Lighting Design Analysis Report

Selmon Expressway Aesthetic Lighting Bid Alternate

Prepared for Tampa Hillsborough Expressway Authority

March 2020

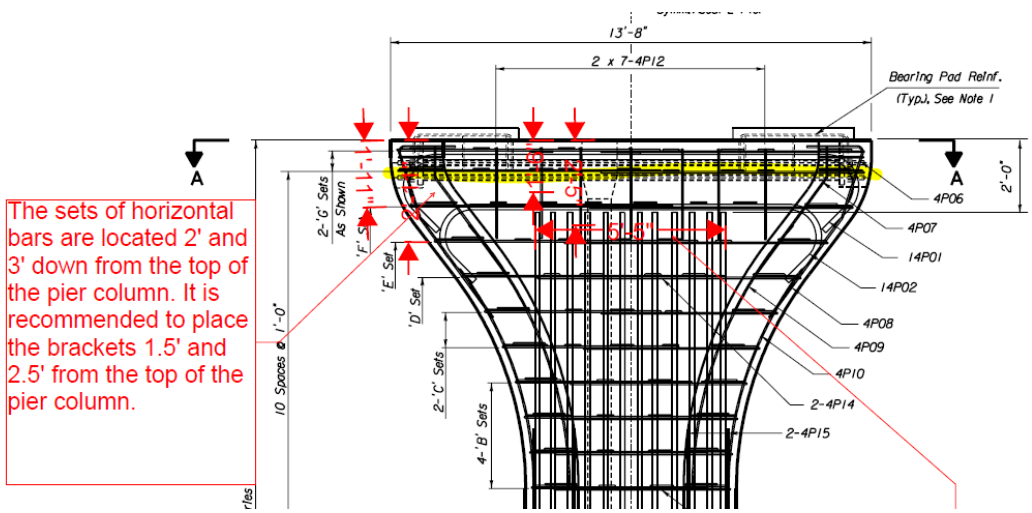
The current aesthetic lighting structural connection at the typical pier locations is shown on plan sheet no. 49. It consists of two mounting brackets with anchor bolts into the pier column per vertical post. This structural connection is mirrored so that is located on both the upstation and downstation face of the pier column. This concept is shown in the three figures below.

The bottom frame that supports the aesthetic lighting luminaires is wide and extends past the pier column. Due to its geometry, it will be subjected to lateral and uplifting wind loads that will produce a torque or wracking of the entire aesthetic lighting support frame. If the vertical posts that extend up and over the top of the pier are not mechanically fastened to the pier column (e.g. anchor bolts into the pier column), the entire support frame will be subject to movement during wind events. In order to prevent this movement, mechanical fasteners/anchor bolts would still be required to fix the support frame to the pier column. Another option would be to implement a thread bar system that would connect the support frames on either side of the pier. The thread bar system would run external to and alongside of the pier column to connect the support frames and providing a clamping force. Because these bars

would be external, this would not be an aesthetically pleasing solution.

The minimum neoprene bearing pad height is 4 7/16" and the minimum heights for both the bearing seat (concrete pedestal under the bearing) and bearing plinth (concrete above the bearing/under the superstructure segment) are each 2". That means that the minimum height from the top of the pier column to the bottom of the superstructure segment is 8 7/16". This leaves very little room to access the vertical strut extensions on top of the pier column to install anchor bolts. Any anchor bolts would need to be installed along the side of the pier column for access purposes.

Based on studying the feasibility of extending the vertical posts up and over the top of the pier column, Kimley-Horn recommends to move forward with the existing concepts where the vertical posts are mechanically fastened to the side of the pier column with anchor bolts. Rebar locating methods using nondestructive techniques are readily available (e.g. ground penetrating radar "GPR" methods) to locate the reinforcing steel and locate where the anchor bolts need to be placed. Locations and dimensions are provided in the aesthetic lighting support frame plans for the contractor to start with their rebar locating methods. The aesthetic lighting support frame will be detailed so that it can accommodate any deviation to the transverse distance between the vertical posts (currently 4'-0") and the brackets supporting the vertical posts (dimensioned from the top of the pier column).
